FINAL PLAT  
PIZZA HUT PAWNEE/HYDRAULIC ADDITION  
AN ADDITION TO WICHITA, SEDGWICK COUNTY, KANSAS

RE: SUB 2000-60 -- One-Step Final Plat of PIZZA HUT PAWNEE/HYDRAULIC ADDITION

RE: SUB 2000-60 -- One-Step Final Plat of PIZZA HUT PAWNEE/HYDRAULIC ADDITION

**CASE NUMBER:** SUB 2000-60 -- PIZZA HUT PAWNEE/HYDRAULIC ADDITION

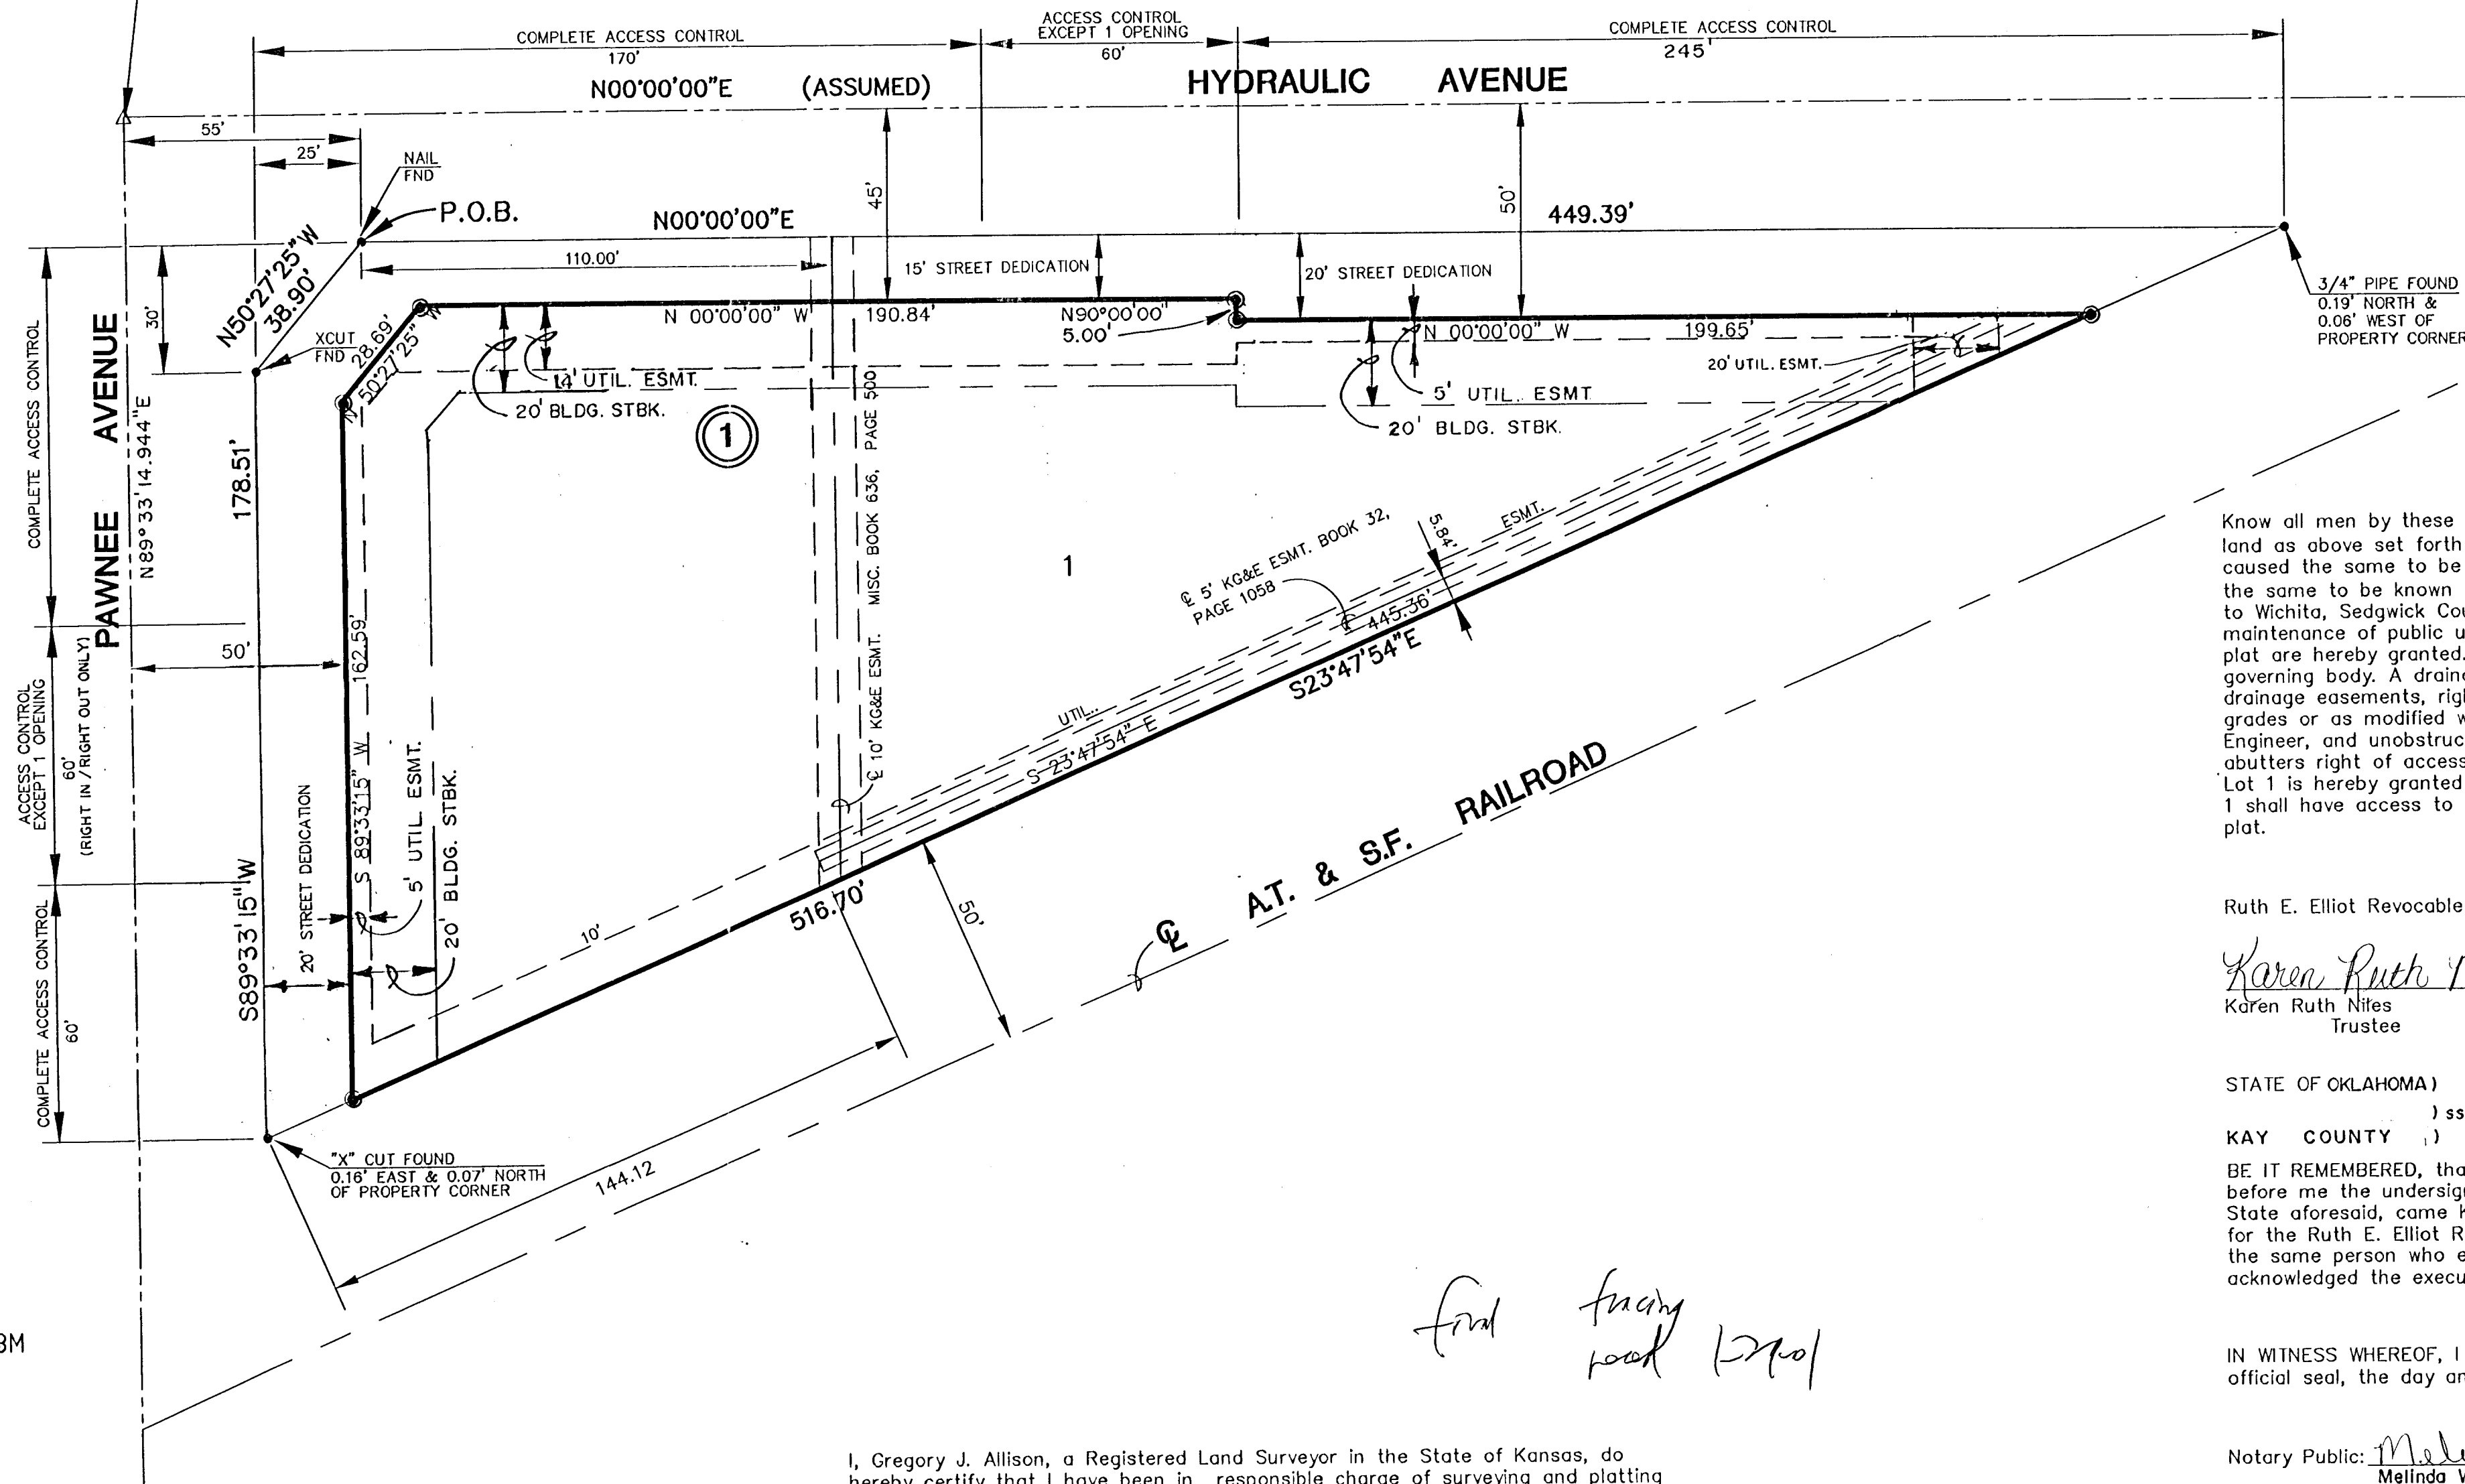
- A. Municipal water and sanitary sewer services are available to serve the site. City Engineering needs to comment on the need for any guarantees or easements. A 20-ft wide easement will need to be platted to cover the existing east-west sanitary sewer line across the northern portion of the site. A temporary easement is needed to cover the sewer line running parallel with the east line of the plat until its removal.

- D. City Engineering needs to comment on the status of the applicant's drainage plan. A revised drainage plan needs to be submitted. As some of the site's drainage is directed onto the adjacent railroad right-of-way, a letter shall be provided from that railroad indicating their willingness to accept such drainage.

- E. Traffic Engineering needs to comment on the access controls. The plat proposes three access openings along Hydraulic and two access openings along Pawnee. 150 feet of complete access control is required from the intersection and from the nearest railroad track. This will necessitate a modification from the Subdivision Committee. Distances should be shown for all segments of access control. The final plat tracing shall reference the access controls in the plat's text. Traffic Engineering has approved one opening along Hydraulic (full turning movements) and one opening along Pawnee (right turns only). The Subdivision Committee has approved a modification of the required complete access control along Pawnee.

- F. **Traffic Engineering** needs to comment on the need for additional right-of-way along Hydraulic and Pawnee. *The Applicant shall dedicate 50-ft of half street right-of-way along the northern 245 feet of the plat's frontage along Hydraulic, 45-ft of half-street right-of-way along the remainder of Hydraulic, 50 feet of half-street right-of-way along the corner clip, and 50 feet of half street right-of-way along Pawnee.*

- H. The owner's name "Noles" on the signature block needs to be corrected to "Niles" as referenced in the platting binder.
- I. The Deputy County Surveyor has advised that the plat boundary does not close.

- J. The "utility setback" along the south needs changed to a "utility easement".
- K. The width of the KGE easement in Book 32, Page 1058 needs to be denoted, along with the location of the south end of the easement.

- L. On the Benchmark, both C's need changed to Centerline.
- M. The legend needs changed from "=I.P." to "=found monument".
- N. Based upon the platting binder, property taxes are still outstanding. Before the plat is scheduled for City Council consideration, proof shall be provided indicating that all applicable property taxes have been paid.
